# The Terraces of Lafayette Environmental Impact Report

SCH # 2011072055

Volume I: Final EIR Chapters

FIGURE 4.13-1  
 PROJECT SITE VICINITY

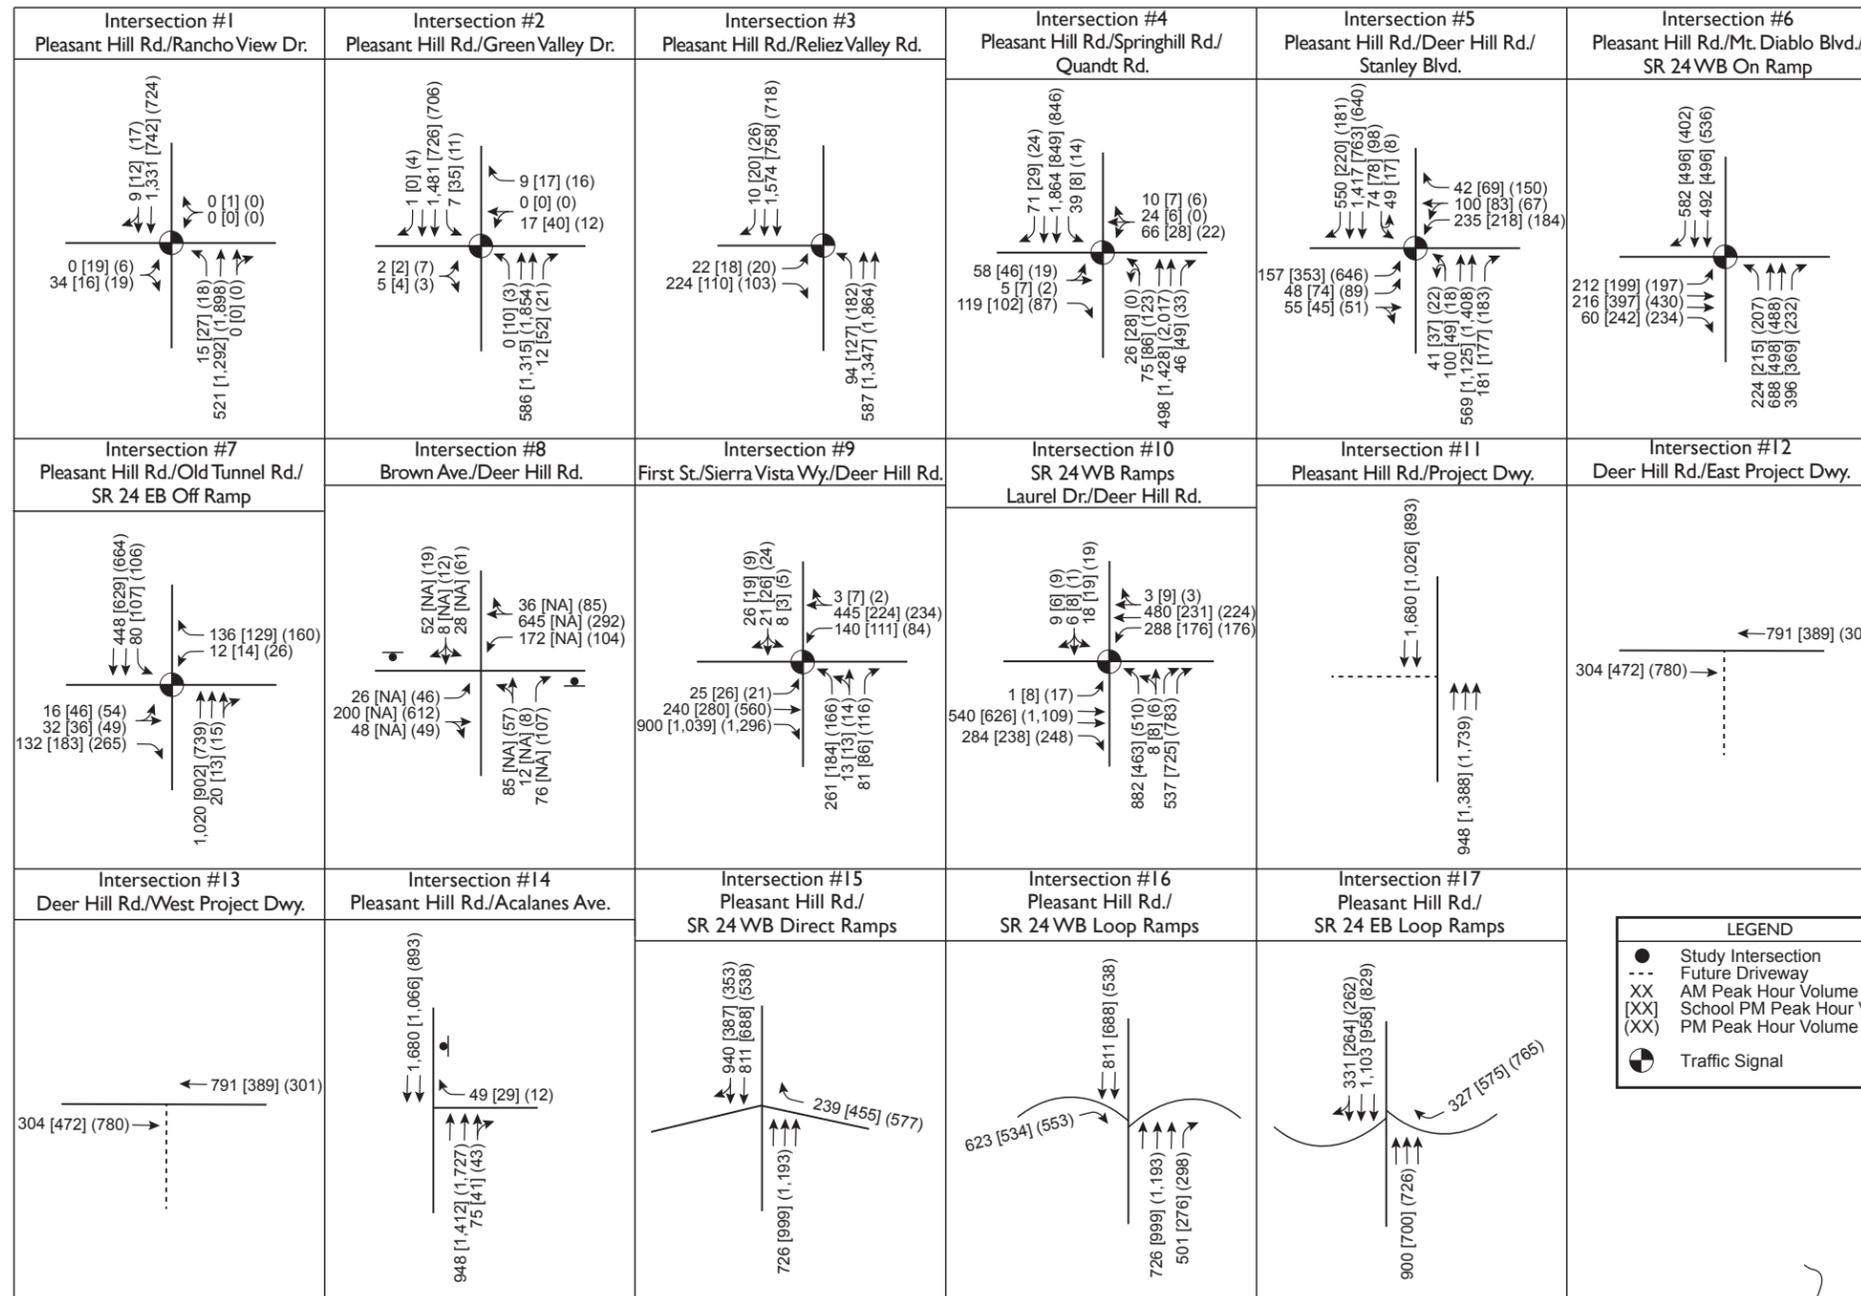
LA1-4	On Figure 4.13-3 and throughout the DEIR on similar figures, intersection #15 is not shown on the map.	Figures 4.13-1, 4.13-2, 4.13-3, 4.13-4, 4.13-9, and 4.13-10 have been revised to show intersection #15, as shown in Chapter 3, Revisions to the Draft EIR, of this Final EIR.
LA1-5	On Figure 4.13-3 and throughout, the lane configuration for intersection #9 in the northbound direction is incorrect. Intersection #14 is a tee-intersection.	The lane configuration for intersection #9 has been verified and is correct in the figures and in the calculations shown in Draft EIR. Figures 4.13-2, 4.13-3, 4.13-4, 4.13-9, and 4.13-10 have been revised to correct intersection #14, as shown in Chapter 3, Revisions to the Draft EIR, of this Final EIR.
LA1-6	The title of Figure 4.13-6 suggests all proposed improvements on Deer Hill Road are depicted, but the figure actually only depicts the easterly improvements. Consider changing the title.	The title of Figure 4.13-6 has been revised as suggested, as shown in Chapter 3, Revisions to the Draft EIR, of this Final EIR.

Figure 4.13-1 on page 4.13-10 of the Draft EIR is hereby amended as shown on the following page.

FIGURE 4.13-6  
PROPOSED PROJECT DEER HILL ROAD AT PLEASANT HILL ROAD IMPROVEMENTS

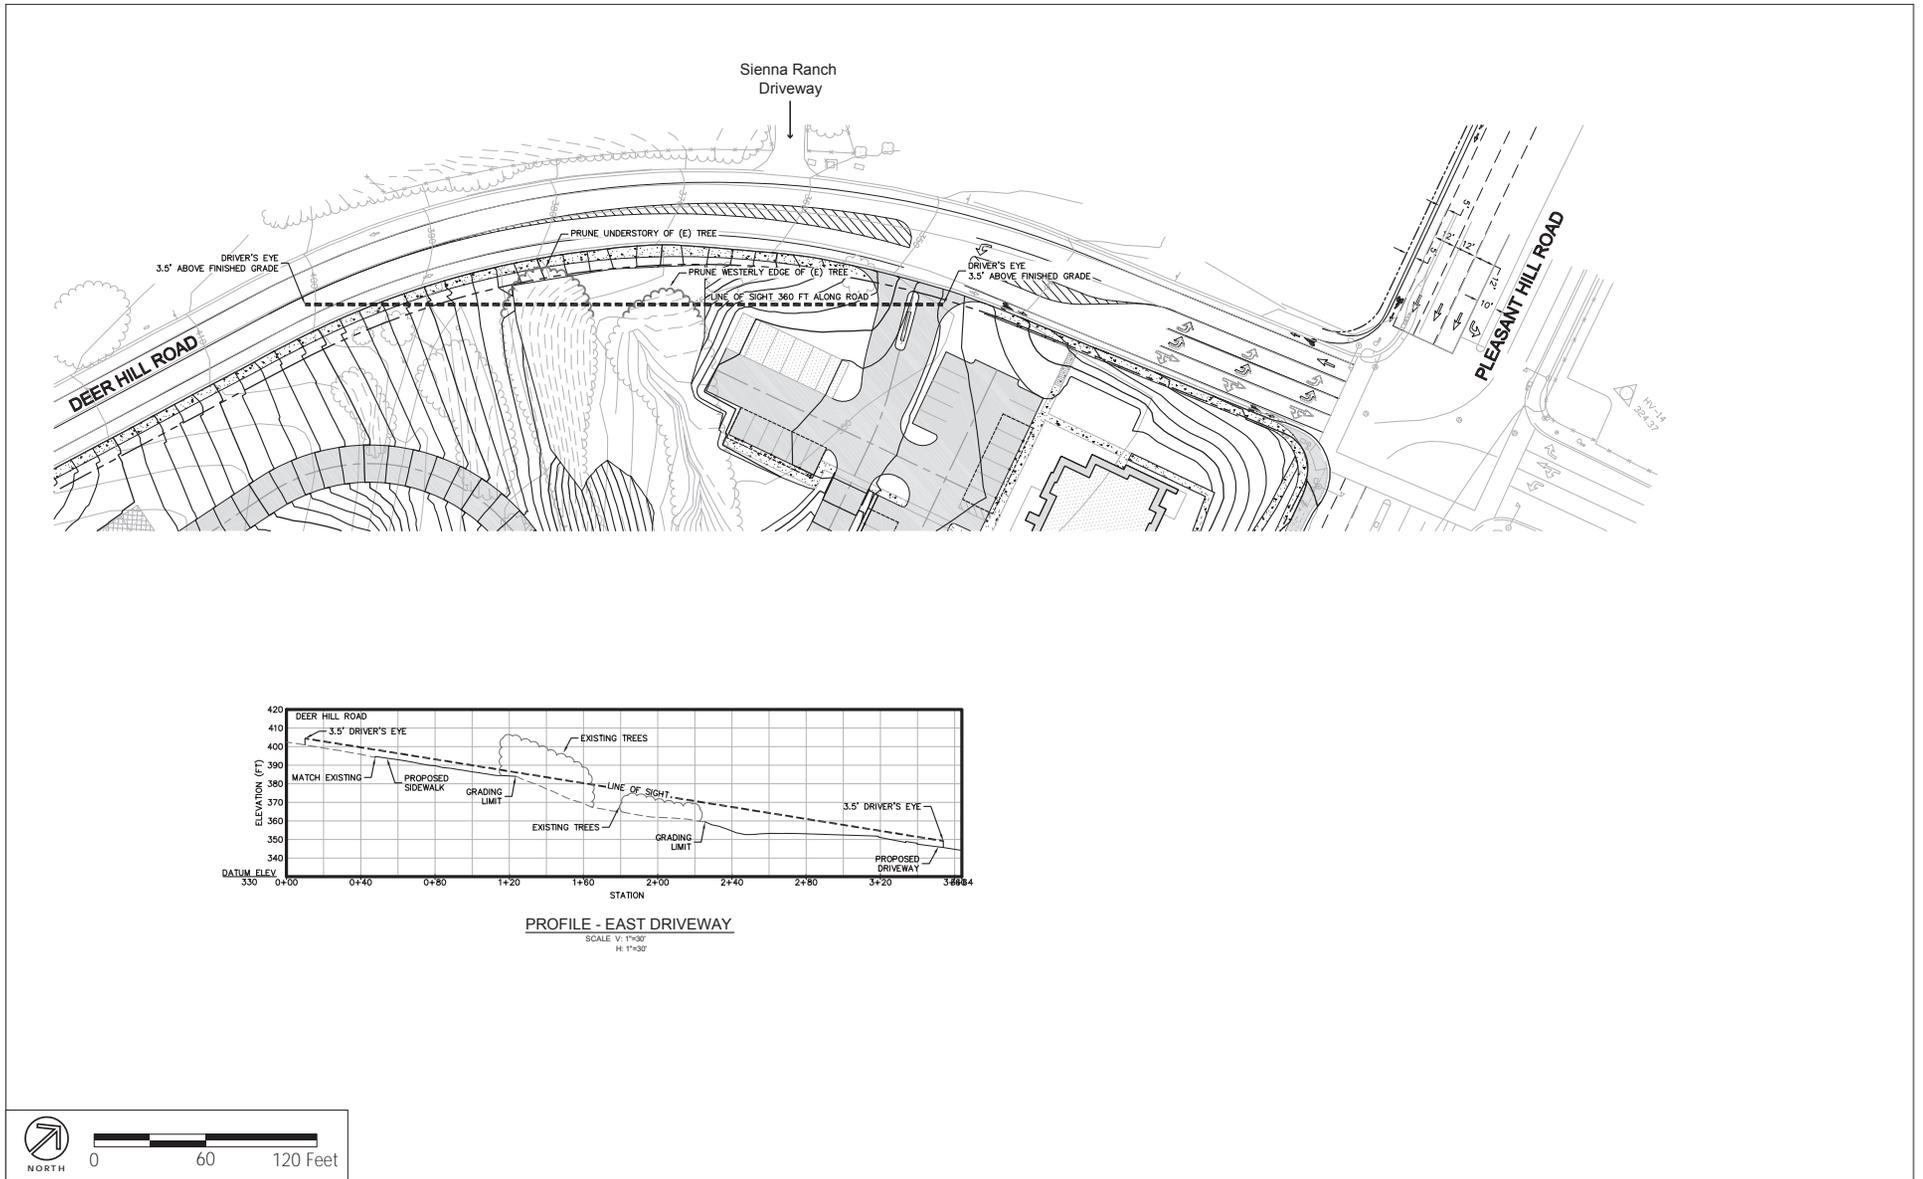
LA1-7	The driveway serving Sienna Ranch at 3232 Deer Hill Road should be clearly shown and labeled in all relevant figures such as Figure 4.13-6.	Figures 4.13-6 and 4.13-7B, have been revised to show the driveway, as shown in Chapter 3, Revisions to the Draft EIR, of this Final EIR.
LA1-8	The proposed medians on Deer Hill Road may interfere with the driveway operations of the Sienna Ranch at 3232 Deer Hill Road across the street from the proposed easternmost project driveway. It appears that the Ranch's driveway may be restricted to right-in and right-out only movements. The DEIR should evaluate and include a discussion on the access into and out of the Sienna Ranch driveway.	As discussed in Mitigation Measure TRAF-5 (as numbered in the Draft EIR), a raised centerline or median features to obstruct the westbound left turn are not recommended on Deer Hill Road at this location because of prevailing speeds, as well as potential obstruction of left turns out of the proposed Project driveway and access at the adjacent driveway on the north side of the roadway. (See page 4.13-85 of the Draft EIR.)

Figure 4.13-6 on page 4.13-33 of the Draft EIR is hereby amended as shown on page 3-37.
